**PLANNED UNIT DEVELOPMENT
& SUBDIVISION STAFF REPORT****Date: June 7, 2007****DEVELOPMENT NAME**

Myers at General Bullard Subdivision

CONTEMPLATED USEPlanned Unit Development approval to allow multiple
buildings on a single commercial building site, and Subdivision approval to create one legal lot
from a metes and bounds parcel.**TIME SCHEDULE
FOR DEVELOPMENT**

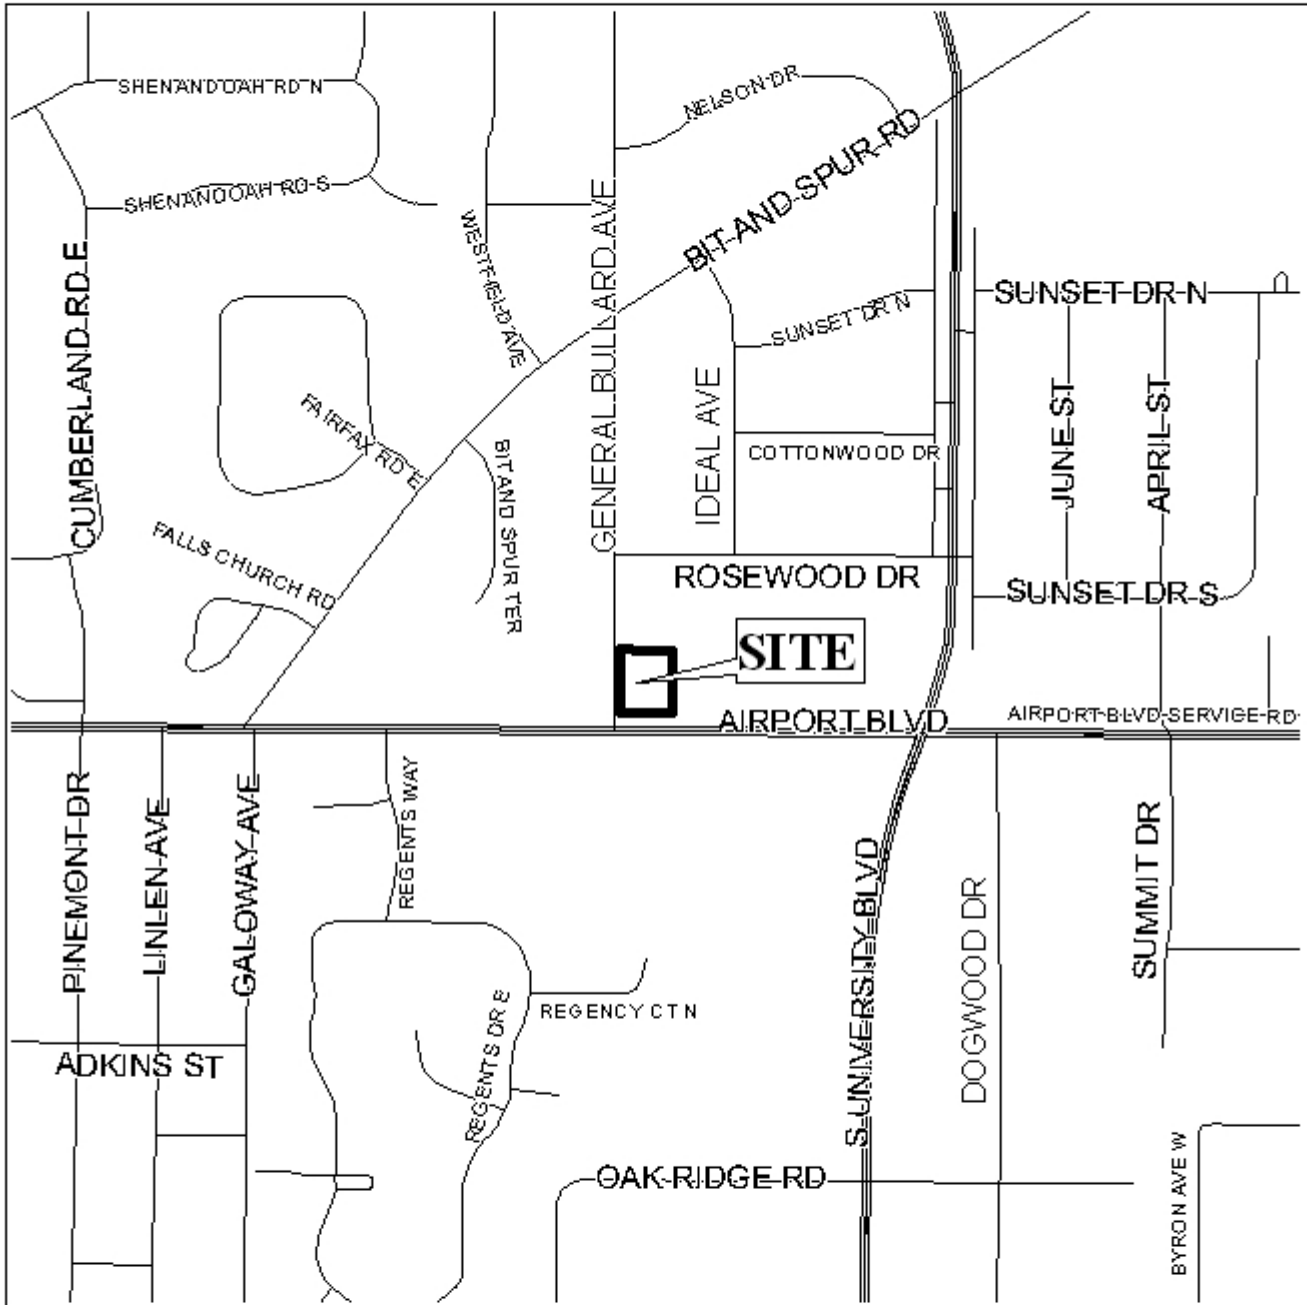
The applicant submitted revised site plan illustrating the reduction of the southern curb cut along General Bullard to entrance only.

There are concerns. The need for an additional entrance only curb cut along General Bullard is unwarranted and unjustified. Allowing this one way entrance in close proximity to Airport Boulevard may hinder the flow of traffic onto General Bullard as well onto the site.

Planned Unit Development: The PUD request is recommended for Approval, subject to the following conditions: 1) the submission of the revised PUD plan illustrating the removal of the southern curb cut along General Bullard; 2) direction of any car washing run-off to an oil separator prior to discharge into the sanitary sewer system; 3) compliance with the lighting requirements of Sections 64-4.A.2. and 64-6.A.3.c. of the Zoning Ordinance; 3) provision of a revised PUD site plan prior to the signing of the final plat; 4)

Subdivision: *1) placement of a note on the final plat stating that the development is limited to two curb-cuts onto Airport Boulevard and one curb cut to General Bullard (located at the North half of the site), with the size, design and location to be approved Traffic Engineering, and to comply with AASHTO standards; and 2) full compliance with all other municipal codes and ordinances.*
